ATA Overlap Proposal

Scope

This document presents the detailed text changes to the ATA-3 document (X3T10/2008Dr2) for the Overlap proposal. It is based on the Overlap proposal submitted by Western Digital Corporation (X3T10/95-258r0) with the changes presented by Quantum Corporation (X3T10/95-257r0).

Figure xx - Proxy interrupt timing

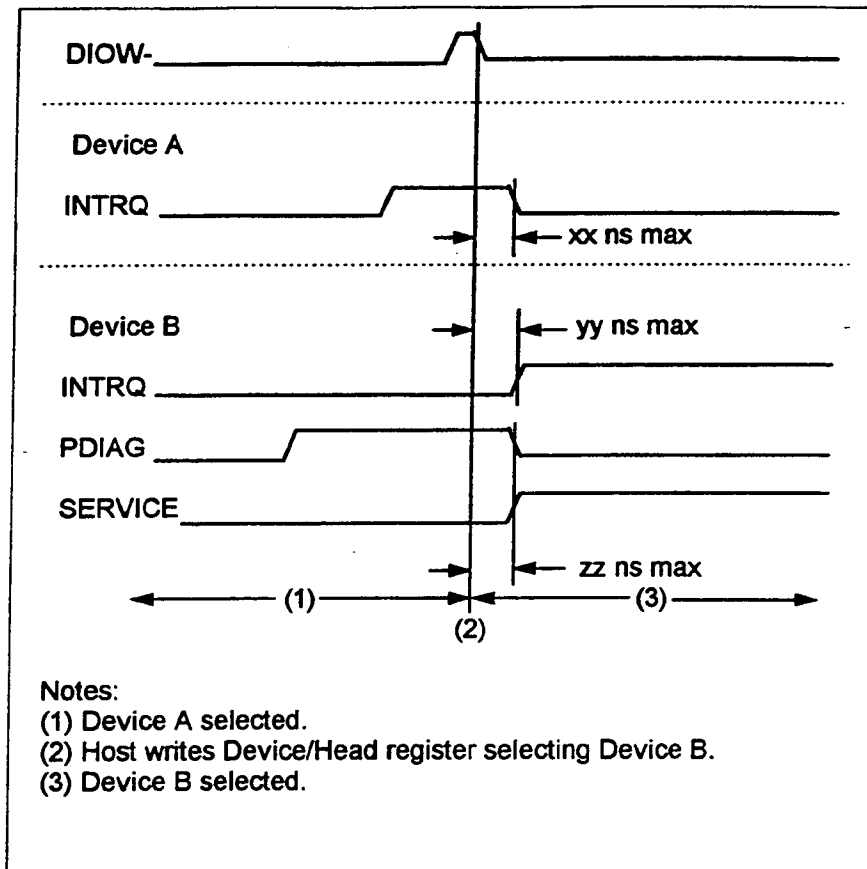
When the ~~SERVICE~~ command is issued Device/Head register is written to select the device with the interrupt pending, the previously selected device shall cease asserting INTRQ within ns. The newly selected device shall set SERVICE, assert INTRQ and negate PDIAG no sooner than ns after the receipt of the SERVICE command but no later than ns. It is possible that the host will see INTRQ negate then reassert. See Figure xx.
